RECALL Child Safety Lock Disengagement

No: RB163
Ref:
Issue: 1
Date: 06 December 2004

Freelander (LN)

Subject: **Vehicle Safety Recall – B163 (NHTSA #04V-207)**

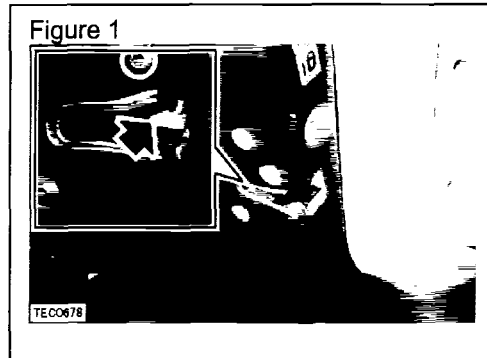
**NOTE: the date code is etched on the door latch and is structured as follows:**

28	11	2
Week	Sequence	Year (2002)

1. Refer to Figure 1 and inspect the door latch date code to determine whether the latch is within the affected range (28112 and 37132).
2. If the door latch date code is **NOT between 28112 and 37132**, no further action is required. Submit a warranty claim for inspection only (Options A or K).

3. If the door latch date code **IS between 28112 and 37132**, perform the following:
 - Refer to GTR repair section 76.37.13 and remove the door latch.
 - Install a replacement door latch with date code above 371332.
 - Refer to GTR section 76.34.28 (linked from the door latch repair section) and install a new water shedder.
